AP- 25 Cushman Street

On reply refer CITY OF PORTLAND, MAINE  
to File AP 25 Cushman Street-I Department of Building Inspection

Subject: Change of contractors on alteration job  
at 25 Cushman Street under building permit al-  
ready issued to cover reconstruction of exist-  
ing rear piazza and other changes

25 Cushman St.  
Back side

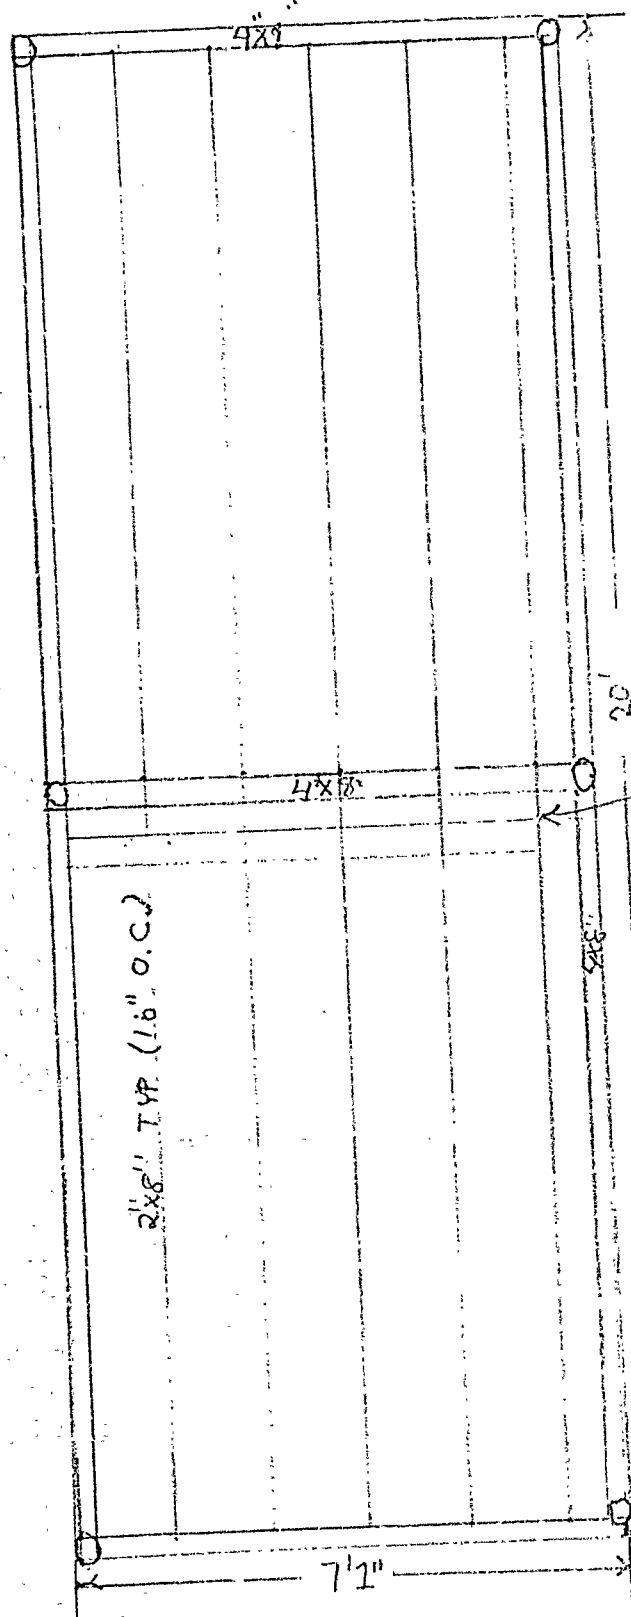
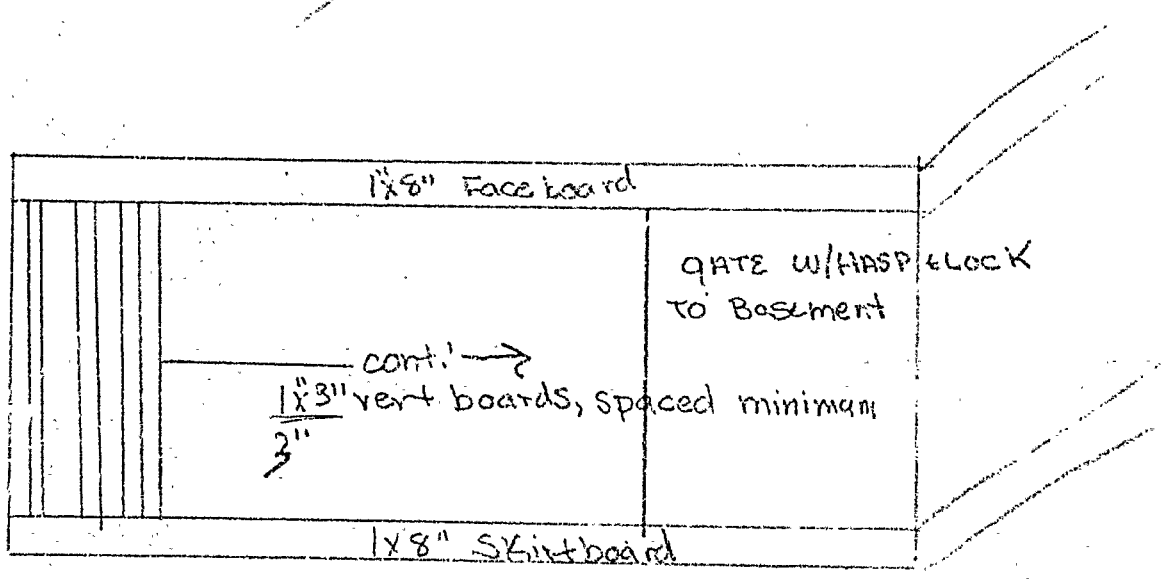
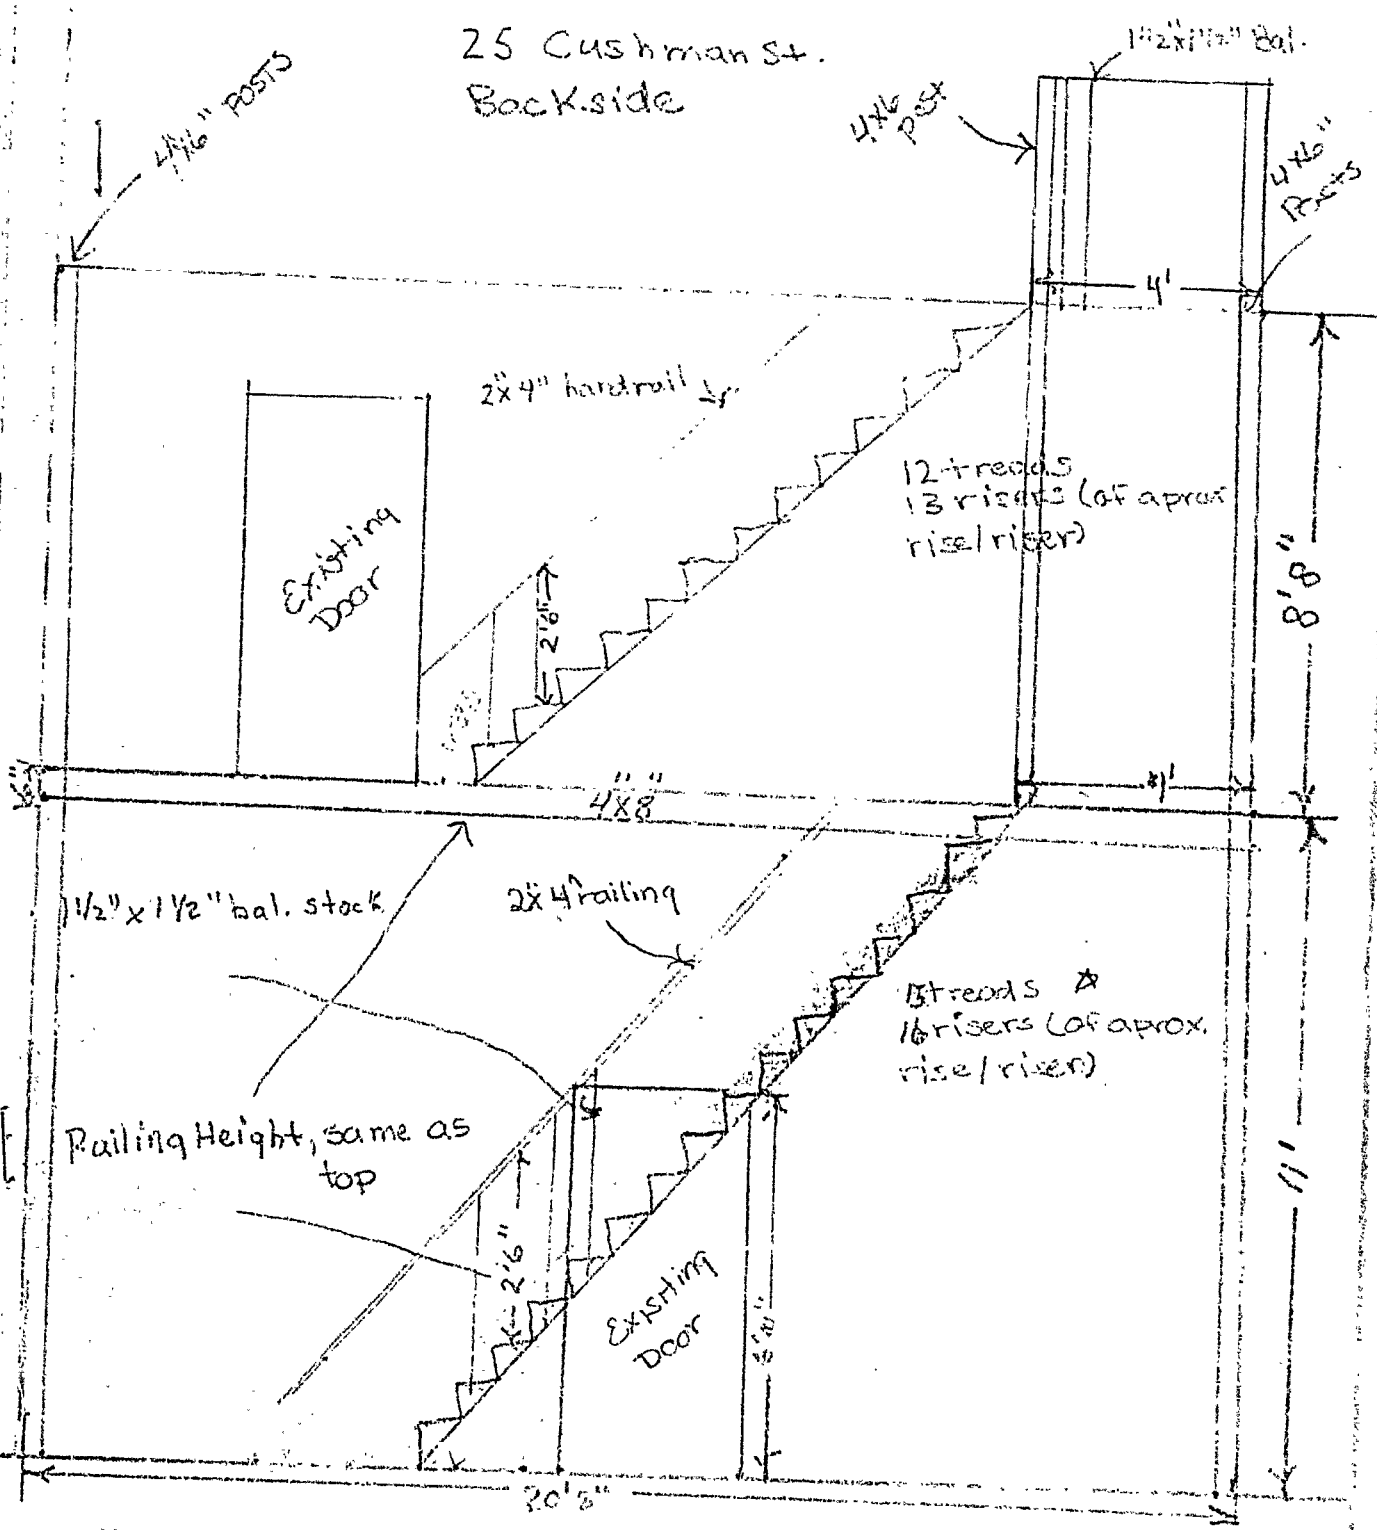
Rise shall be no more than 8" or less than 7"  
 Treads " " minimum of  $\frac{10}{9\frac{1}{4}}$ " width  $\frac{3}{8} = 1'$   
 Shall increase stairwell,  $\frac{1}{2}$  by 1' to increase head room
